806 US Route 1 Bypass
Project Description

May 17, 2024

Site Plan

806 Route 1 Bypass

TITLE
**EXISTING
CONDITIONS
PLAN**
806 US-1 BYP.
PORTSMOUTH, NH 03801
TAX MAP 161, LOT 43

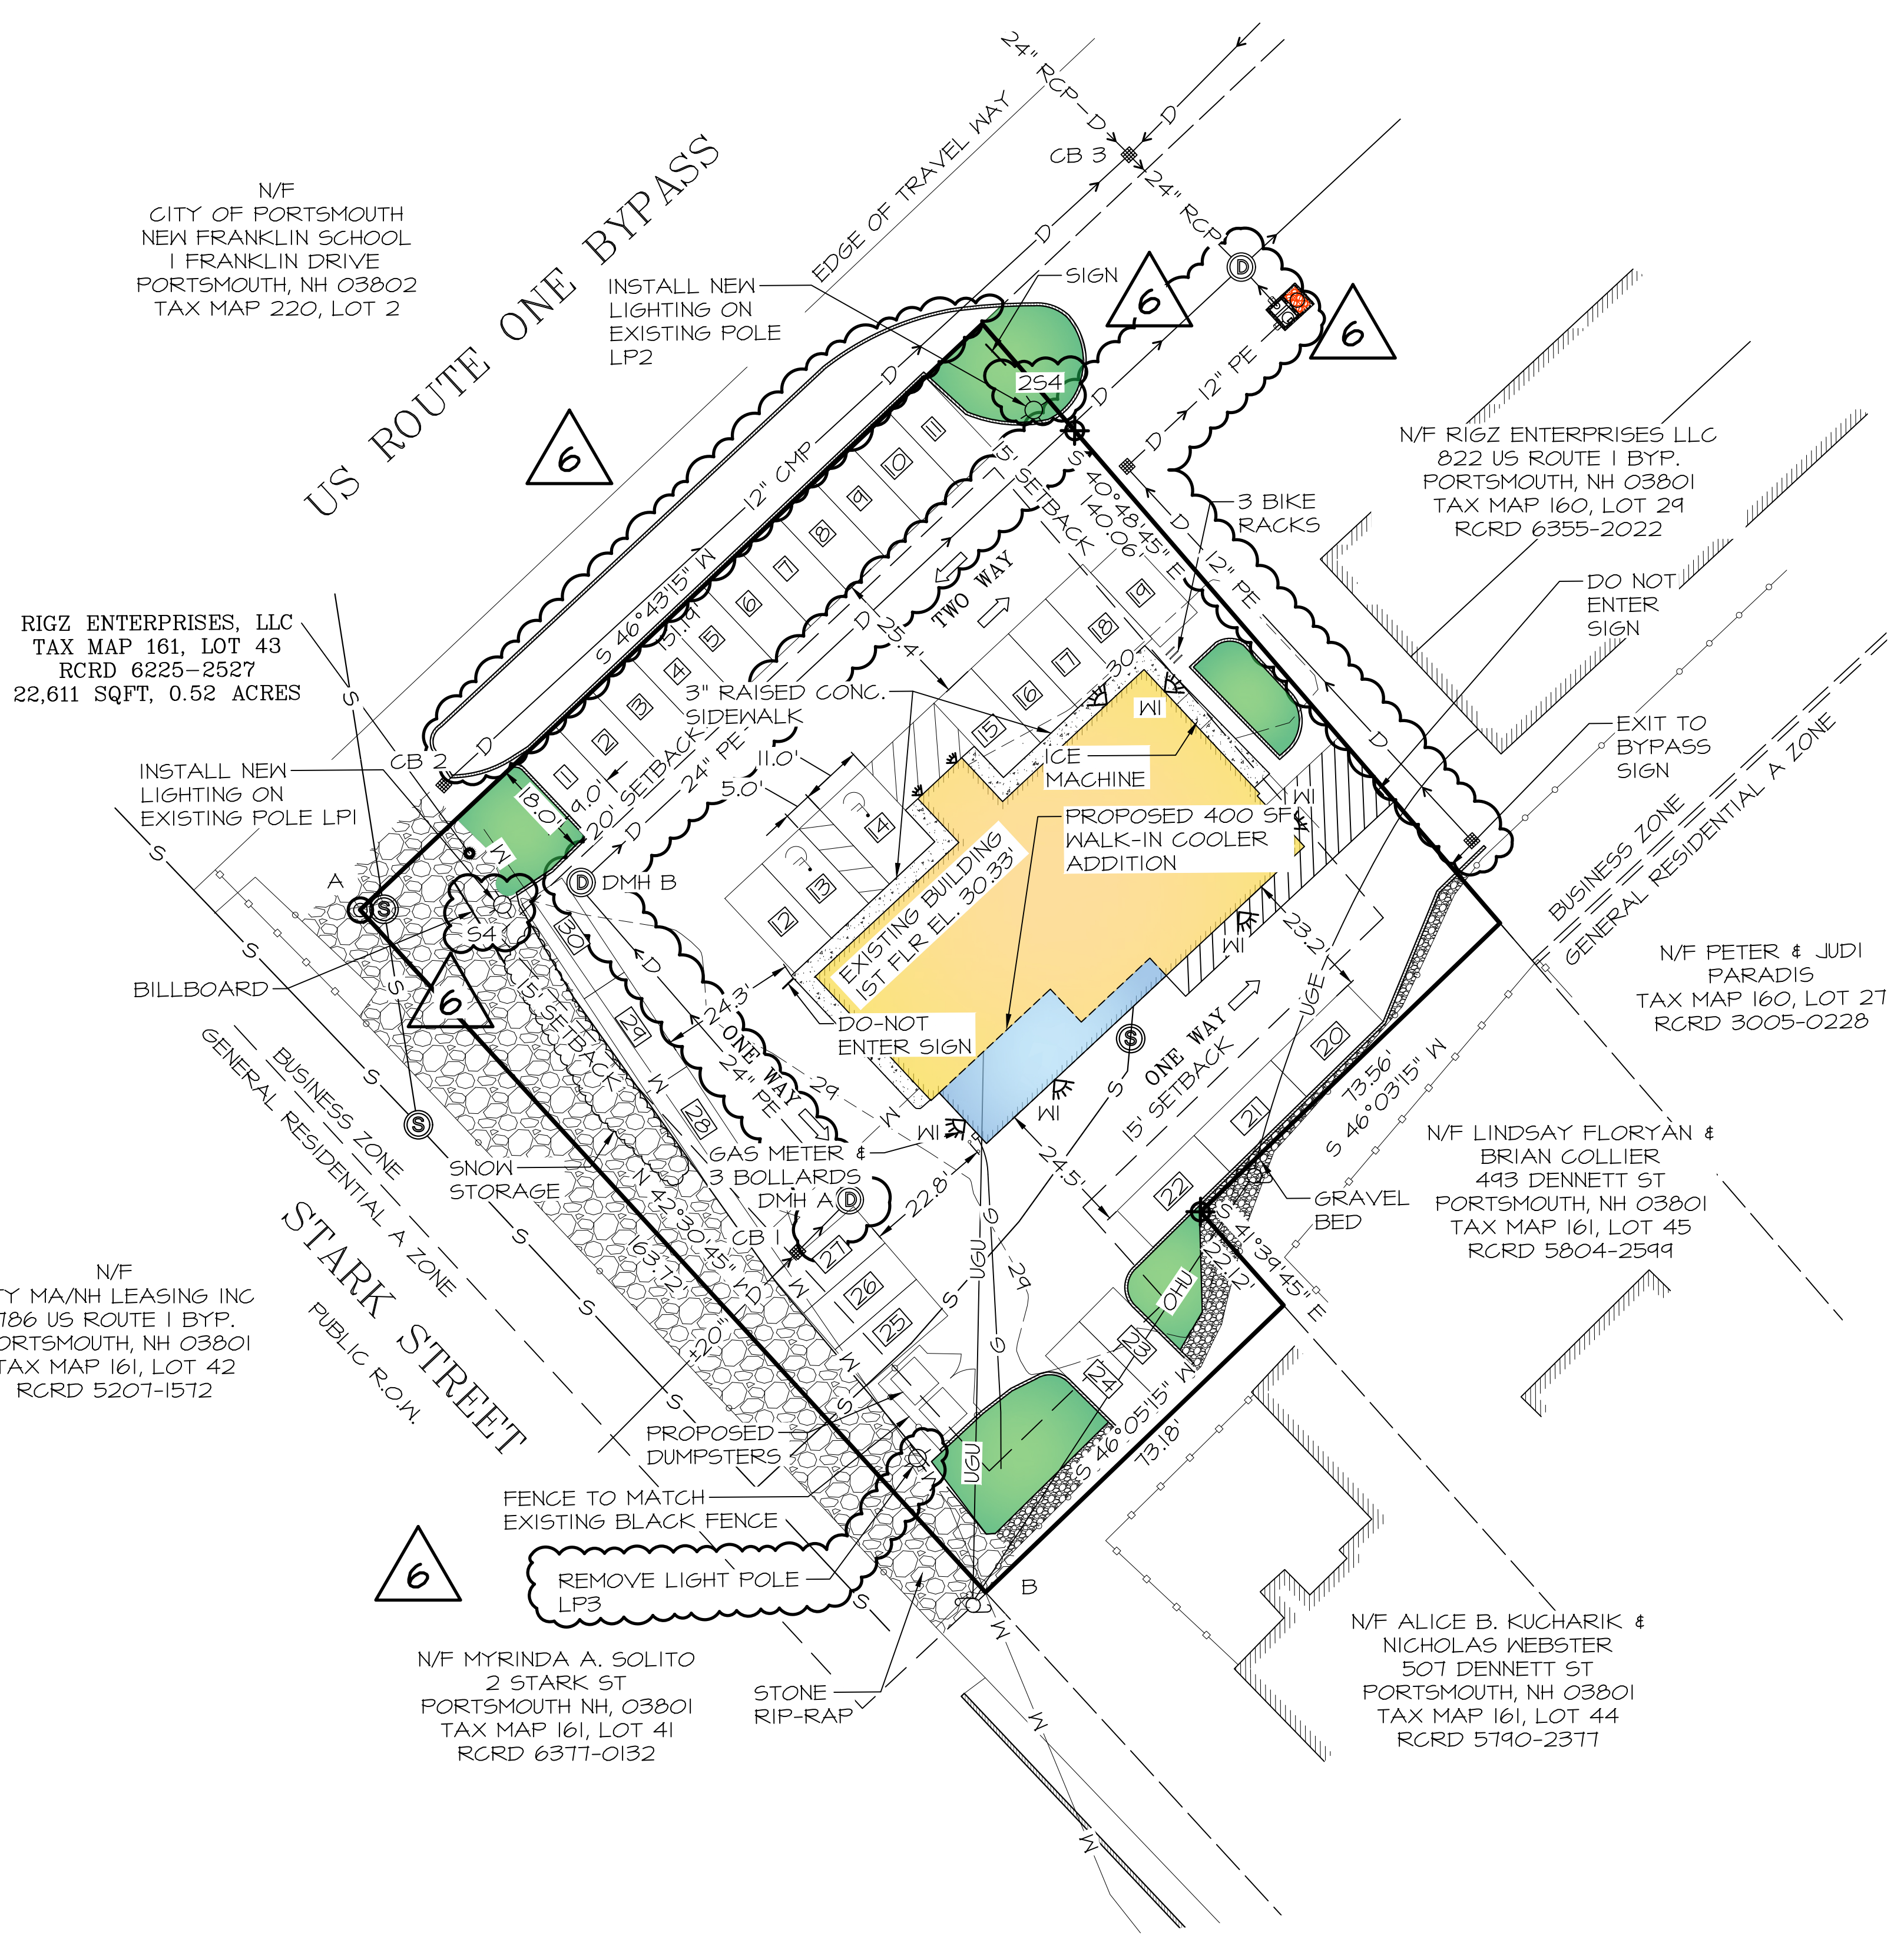
Drawing 1 – Existing Conditions Plan

- Revised existing catch basin elevations
- Added note 6 outlining PB approval and extension of approval.

- REVISED CATCH BASIN ELEVATIONS
- ADDED NOTE 6 TO OUTLINE PB APPROVAL AND EXTENSION OF THIS PROJECT.

SITE PLAN

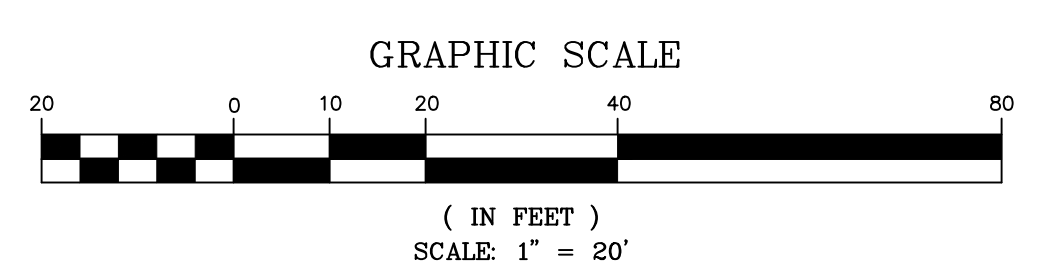
Drawing 2 – Site Plan

- Landscaping removed in NHDOT right of way, as per NHDOT request. This is shown on drawings 2-4.
- Drainage has been changed to depict new proposed drainage system. New drainage system is depicted to match proposed drainage on lot 29, which is connected to drainage system on lot 43. This is shown on drawings 2 & 3.
- Revised lighting callouts on the plan.

- LANDSCAPING REMOVED IN NHDOT RIGHT OF WAY AS PER NHDOT REQUEST.
- DRAINAGE HAS BEEN CHANGED TO DEPICT NEW PROPOSED DRAINAGE SYSTEM. NEW DRAINAGE SYSTEM IS DEPICTED TO MATCH PROPOSED DRAINAGE ON LOT 29, WHICH IS CONNECTED TO DRAINAGE SYSTEM ON LOT 43.
- REVISED LIGHTING CALLOUTS ON THE PLAN.

TITLE
LANDSCAPE PLAN
806 US-1 BYP.
PORTSMOUTH, NH 03801
TAX MAP 161, LOT 43

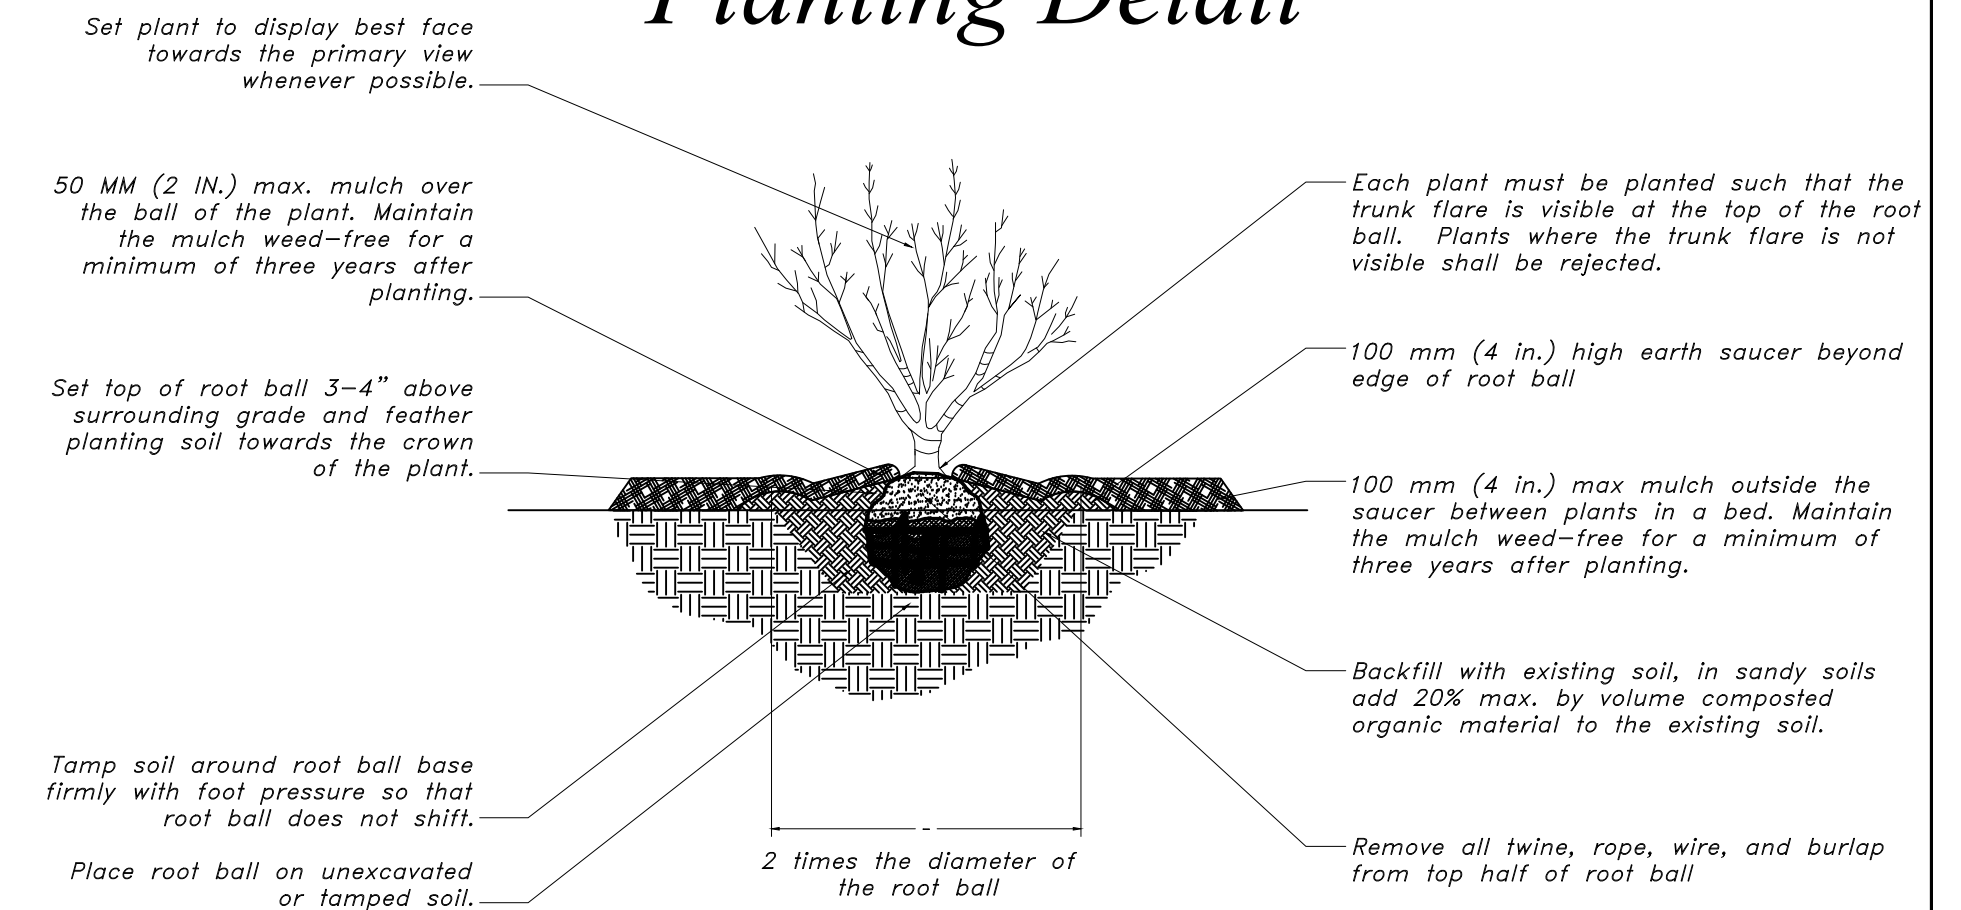
Drawing 4 – Landscape Plan

- Landscaping removed in NHDOT right of way as per NHDOT request.
- Drawing 4 “Landscape Plan” has been changed to depict new proposed manhole and catch basin locations.
- Planting notes have been changed to reflect landscaping that has been changed to reflect landscaping that has been removed in the NHDOT right of way.

- LANDSCAPING REMOVED IN NHDOT RIGHT OF WAY AS PER NHDOT REQUEST.
- LANDSCAPE PLAN HAS BEEN CHANGED TO DEPICT NEW PROPOSED MANHOLE AND CATCH BASIN LOCATIONS.
- PLANTING NOTES HAVE BEEN CHANGED TO REFLECT LANDSCAPING THAT HAS BEEN REMOVED IN THE NHDOT RIGHT OF WAY.
